ADDENDUM NO. 5

New Castle County Vocational Technical School District
Hodgson Vo-Tech High School
Bid Package E - Fieldhouse, Athletic Fields, and Storage Buildings

January 12, 2026

7.2 PANEL

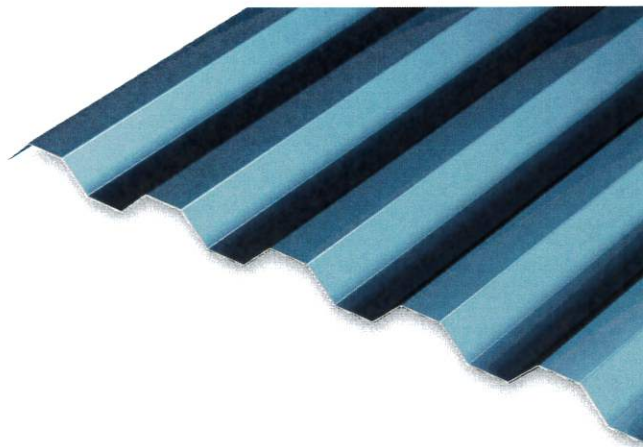
3. PAC CLAD 7.2 is approved as an equal to the specified metal roof and wall panels, Section 074213.13. Material is to be .050 aluminum as specified. See attached spec sheet.
